Department of
Environment and Conservation

STRAITS SALT PTY LTD YANNARIE SOLAR SALT ERMP: (ASSESSMENT NO. 1521)

I refer to Mr Tacey's letter of 1 December 2006 requesting comment on the proposal referred to in this Environmental Review and Management Programme (ERMP). The Department of Environment and Conservation (DEC) provides the following advice and comments on the basis of its *Conservation and Land Management Act 1984* (CALM Act) and *Wildlife Conservation Act 1950* responsibilities for your consideration in assessing this proposal.

Figure 2: Primary footprint of the proposal in relation the Exmouth Gulf supratidal flats. (Source: Figure 2-2 page 2-24 of the ERMP.)

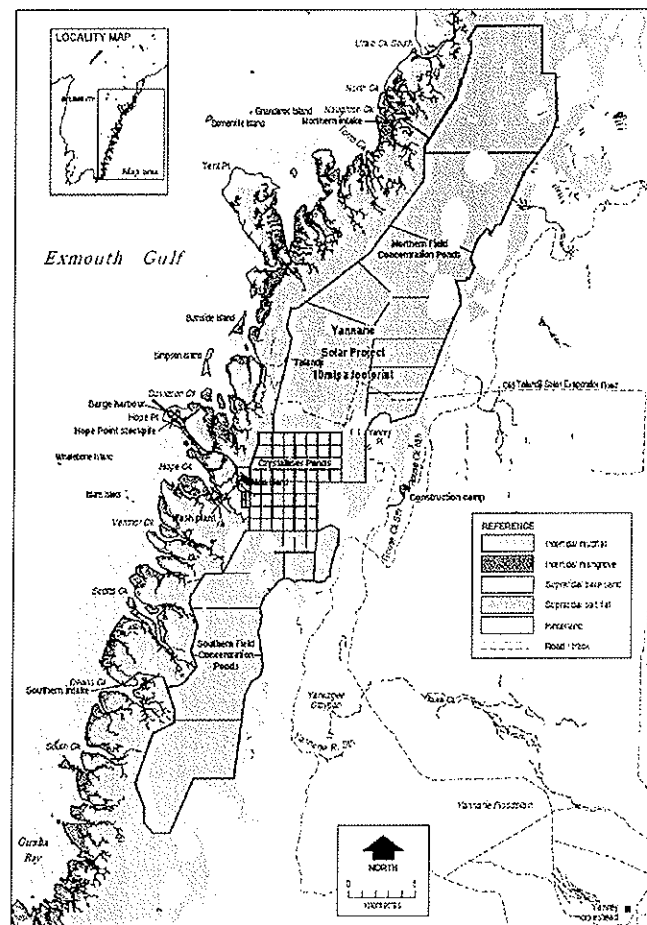
The very large scale of the proposal, encompassing extensive areas of evaporation ponds and other infrastructure will impact on the majority of the Exmouth Gulf supratidal flats, which are regarded as an essential and integral component of the marine and coastal ecosystems of the Gulf. This will result in a major direct loss of the habitat and ecological function values of the supratidal flats, large scale changes to surface water flows, and the disruption of ecological linkages to the Exmouth Gulf. As a result there is a significant likelihood of long-term adverse ecological consequences for primary producing communities in the eastern Gulf, including algal mats, regionally significant mangroves and productive seagrass beds supporting an important prawn fishery and conservation significant macrofauna species (discussed in detail in Sections 1, 2, 3 and 4 of this submission). There may also be significant impacts on fauna that utilise the supratidal flats during or following episodic disturbances such as cyclones.

Figure 3 Outline of Yannarie Solar Salt proposal salt pond footprint superimposed over: a) Exmouth Gulf and b) Perth Metropolitan Area (Source: Conservation Council Western Australia).

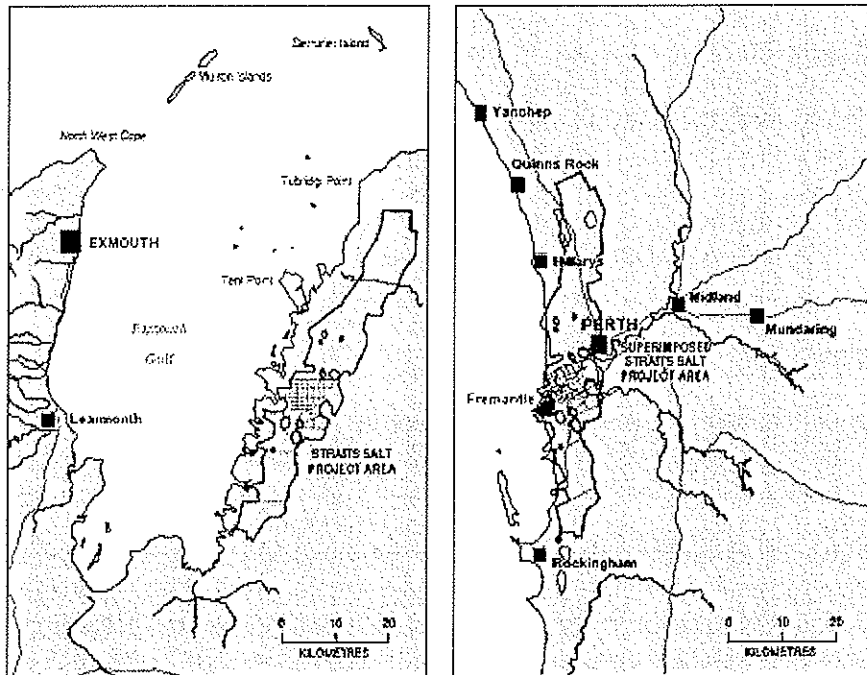
Firstly, surface water flows to an estimated 66 km of coastline will be disrupted and/or prevented and these flows will be redirected around the bunds containing salt ponds with little resultant flow seaward across the supratidal and intertidal mudflats to the mangroves. It is considered likely that these flows contain ecologically important fresh water and nutrient supplies to the Gulf and contribute to groundwater recharge.

Figure 4: Surface water flow from Cyclone Bobby (approximately 300 mm of rain) 1995 illustrating surface water flow from hinterland, across supratidal flats and into Exmouth Gulf. This image was taken March 3, 1995. Source: NASA 2006.

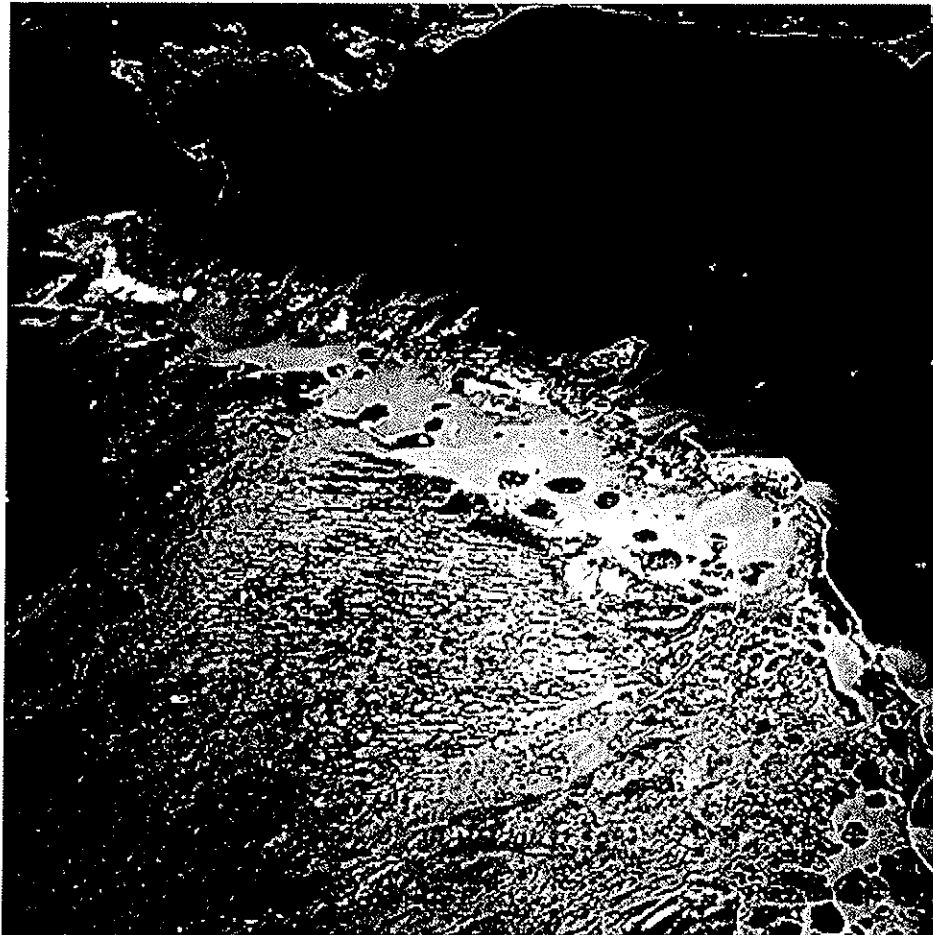
In relation to surface flows from the terrestrial catchment, satellite imagery (Figure 4) taken shortly after Cyclone Bobby in 1995 illustrates that the whole region along the eastern side of Exmouth Gulf may form a major delta system during and after major storms and other rainfall events. Specifically the appearance of turbid water 'plumes' entering the Gulf via major creek systems in the photograph serves to highlight the potentially important function of the supratidal flats in the export of surface water from the hinterland areas to the Gulf during these extreme, but likely to recur, events.

The proponent's conclusion within the ERMP that surface water flow events do not significantly affect the algal mats, groundwater, mangroves and overall productivity of the Gulf (section 3.4.2 'Diversion or redirection of Yannarie River flows' page 5-40 – 5-48 of the ERMP) is considered to be of questionable validity. In particular, there is a high level of uncertainty surrounding the actual importance of surface water flows for groundwater recharge, the quality of groundwater below the supratidal flats and the ecological value of freshwater flows direct to benthic habitats during and immediately following storm events, as well as during wet seasons.

Figure 6: Area of Exmouth Gulf Affected By Guideline 1 within Guidance Statement No 1.

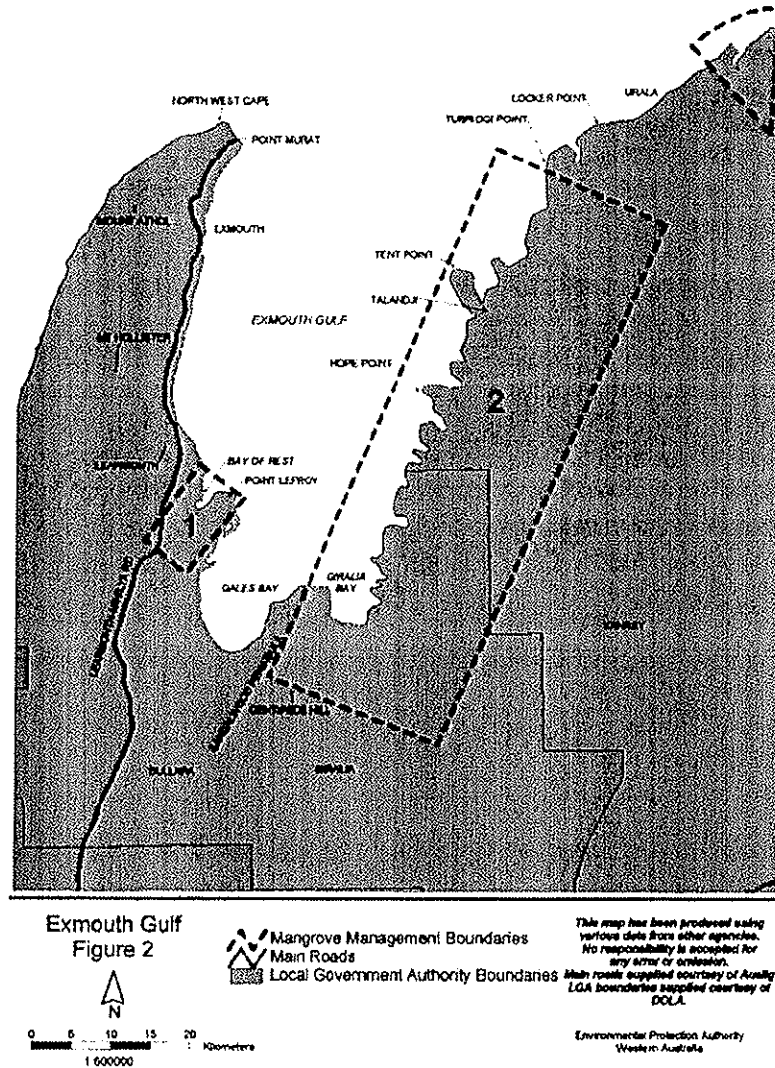
Figure 6 depicts the areas of Exmouth Gulf to which Guideline 1 of Guidance Statement No. 1 applies.

25. The EPA should apply the policy referred to in Guidance Statement No. 1 and not support industrial development on the eastern side of Exmouth Gulf, recognising the potential adverse impacts of the proposal on these regionally significant arid zone mangrove communities. These impacts potentially include alteration of groundwater hydrology, large scale modifications to surface water flows, erosion and sedimentation of tidal creeks and alteration of coastal processes.
